ADDENDUM NO. 2

Invitation for Bids No. 32231R

PVD Canopy Drainage Repairs and ADA Modifications

Rhode Island T. F. Green International Airport

SECTION

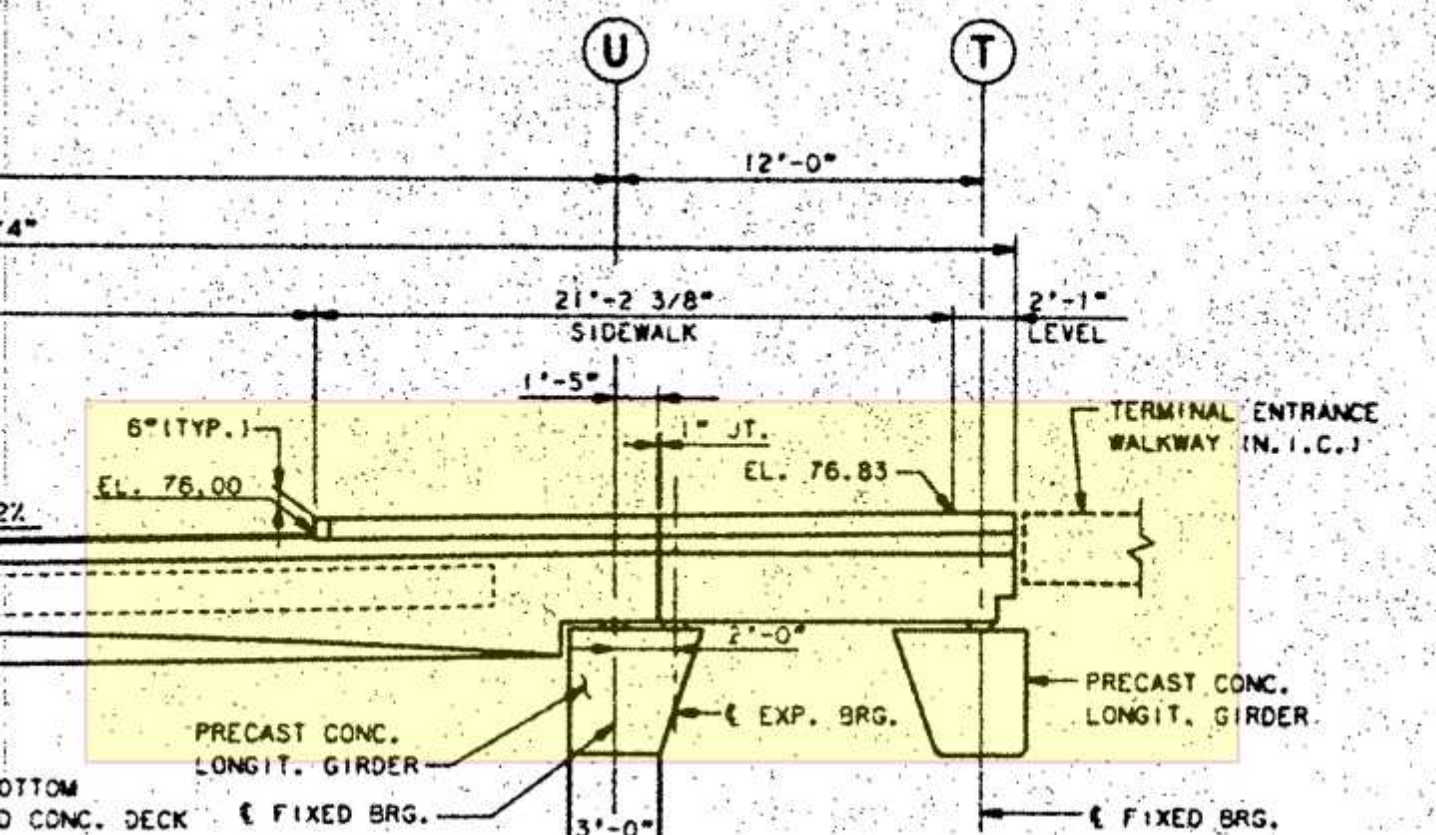
- m. Can you please provide a cut section of the existing elevated deck assembly? **Sections through the existing elevated deck assembly are shown on Drawing A5.11, Detail 3 with information taken from existing drawings. Additional information may be shown in the Landside Improvements Contract 3365X611 drawings by HNTB, dated 3/15/94 and in the T.F. Green Terminal Improvement drawings, dated 9/8/94. Some representative sections are attached to this addendum.**
